Addendum No. 1

Bid Opportunity: 7159-RW-22 – Smithson PS Office and HVAC Upgrades.

Closing Date: Monday, March 14th, 2022 2:00 PM

Sheet Number Revision
E2 1

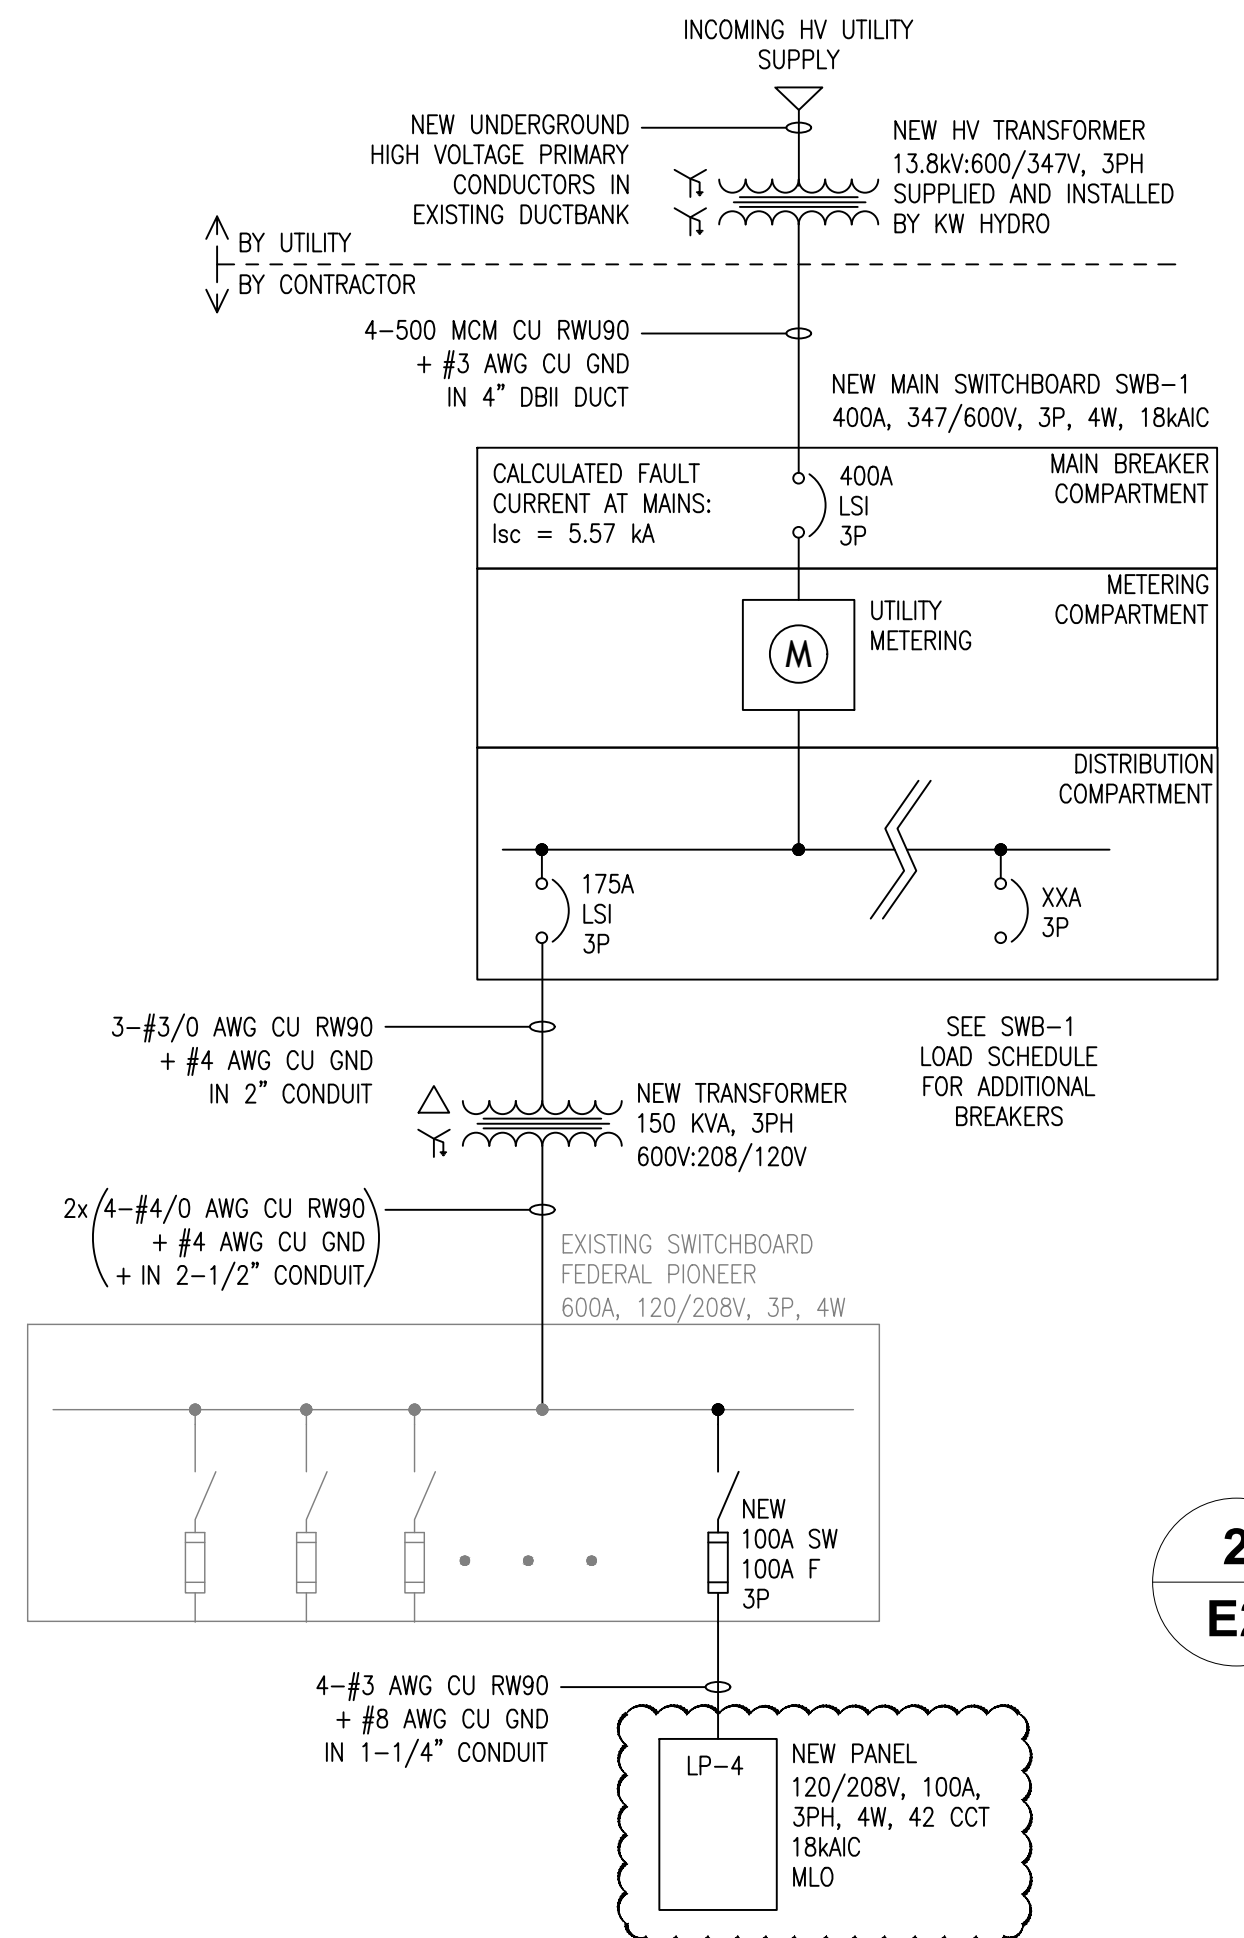
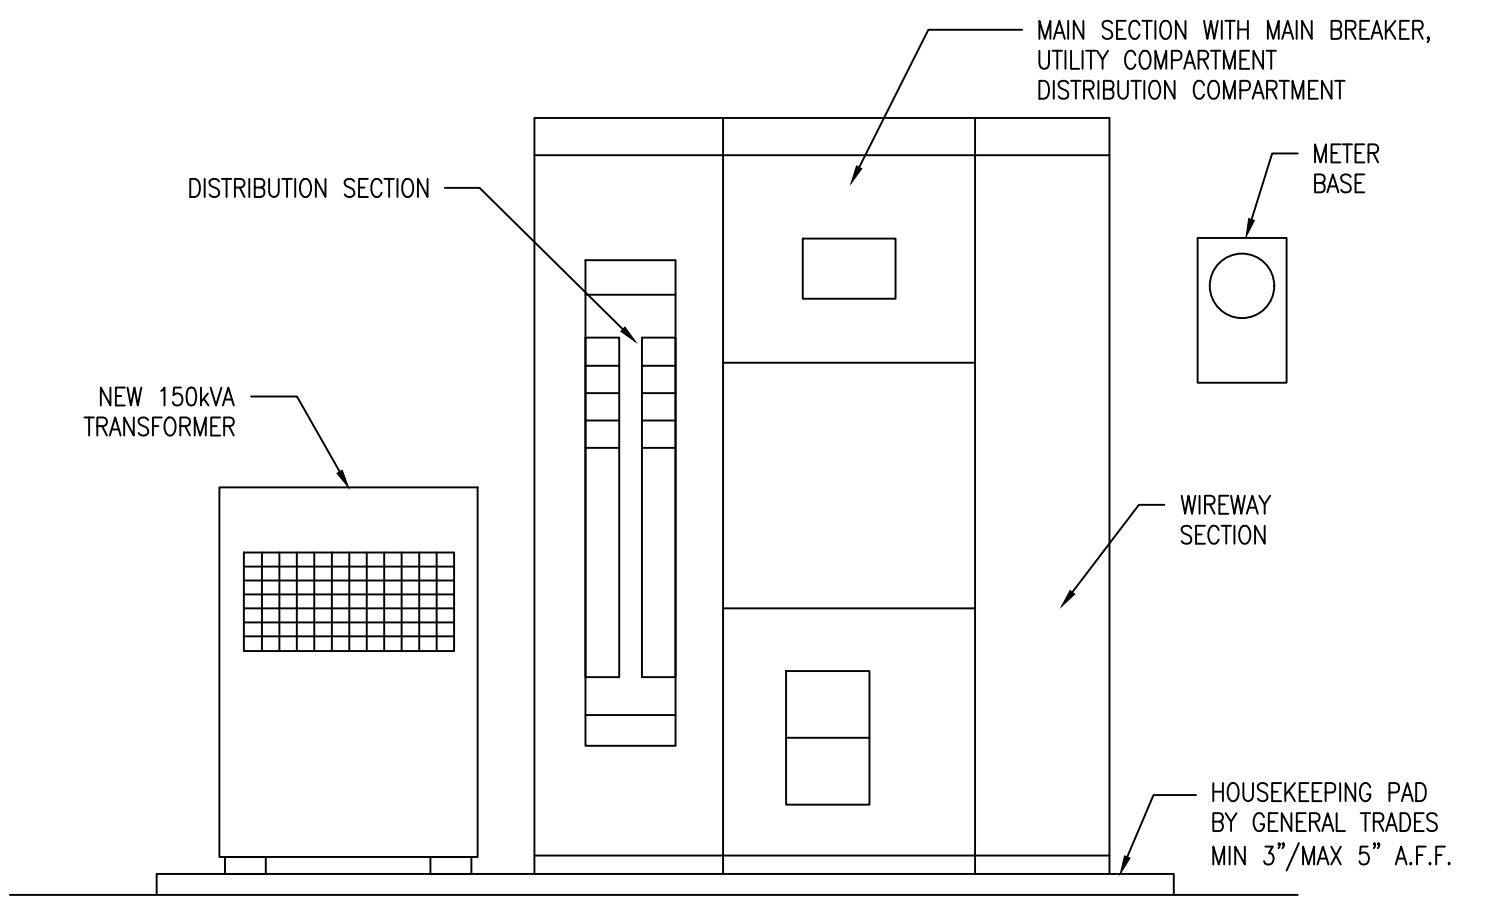
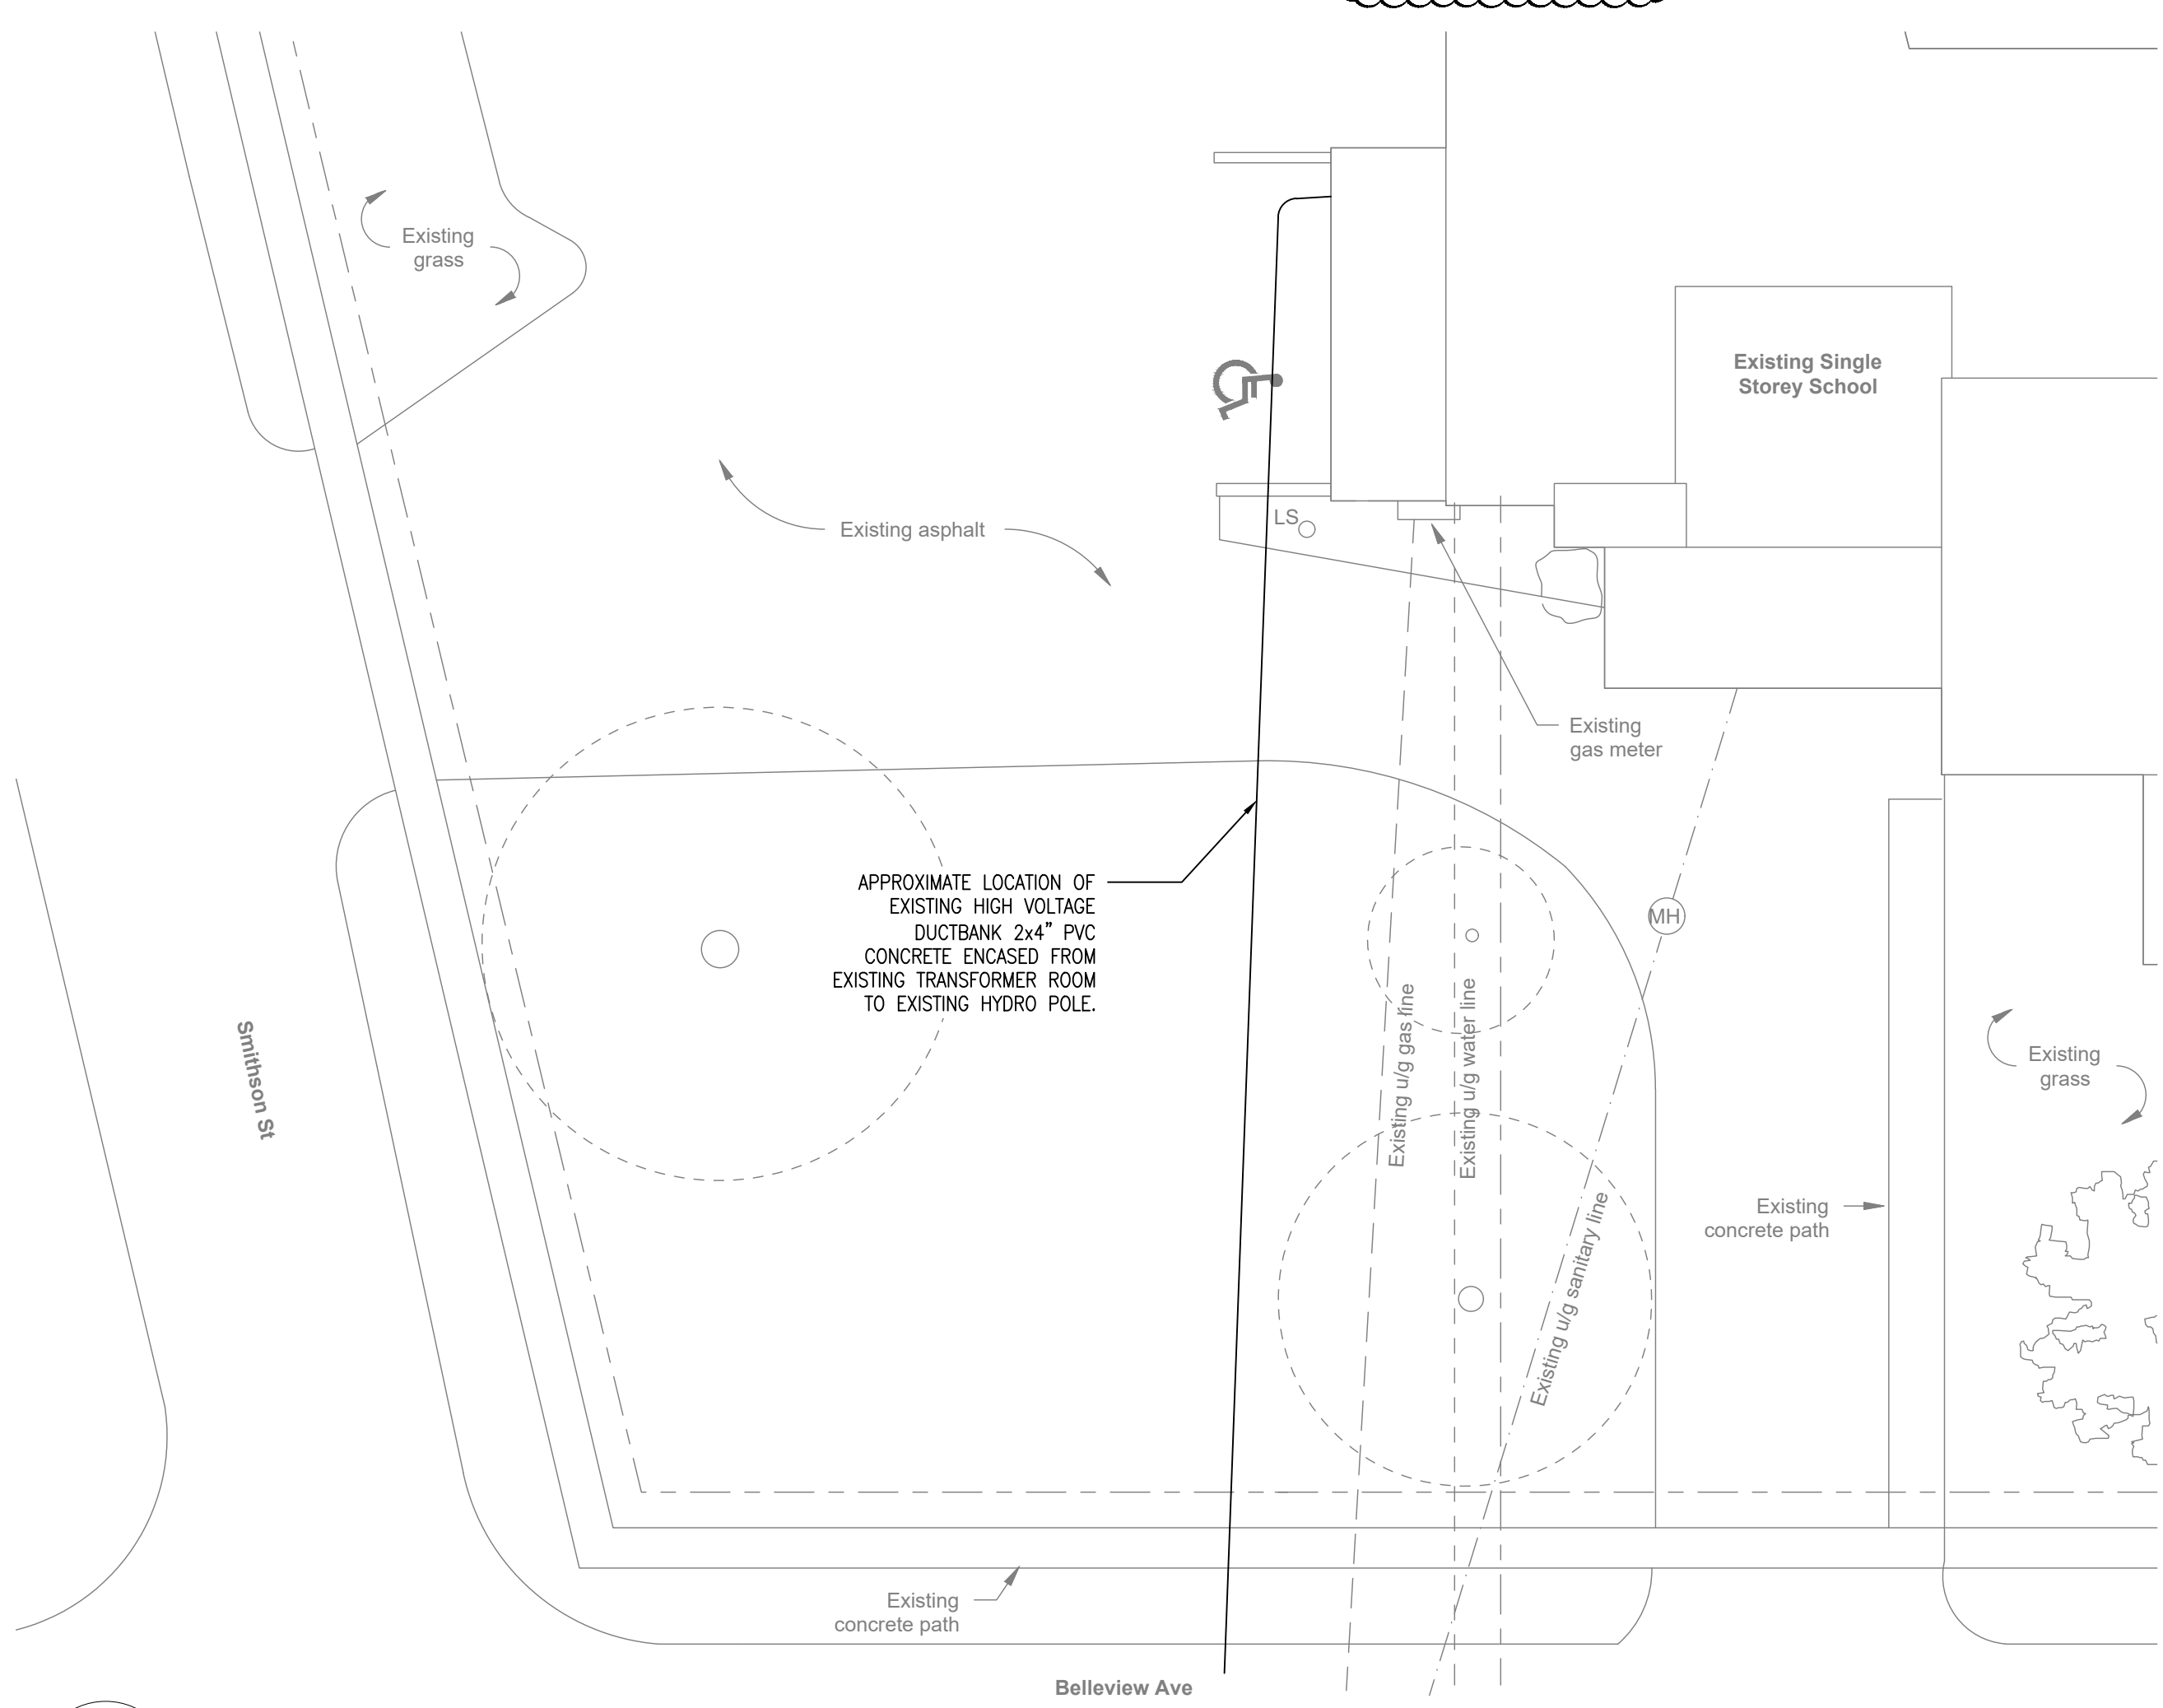
**3. REFERENCE DRAWING E2 – ELECTRICAL SINGLE LINE DIAGRAM AND
SITE PLAN (ISSUED FOR ADD-E01)**

1. The demolition of the existing ‘LP-2’ panel has been removed from the scope of work. The panel is existing to remain and the contractor shall revise the circuit breakers within the existing panel to suit new loads as per the updated panel schedule. Remove and dispose of obsolete breakers and supply and install new circuit breakers as required.
2. The new 100A,208V,3P switch within the existing 208V switchboard has been revised to feed the new panel ‘LP-4’. The supply and installation of one (1) new 100A,208V,3ph,4W panel ‘LP-4’ has been added. Refer to drawings for additional information and panel schedules. Supply and install new circuit breakers as required. Note 7 has been revised to indicate the revised scope of work.
3. Some of the devices fed from LP-2 have been revised to be fed from LP-4. Refer to updated panel schedules for more information.
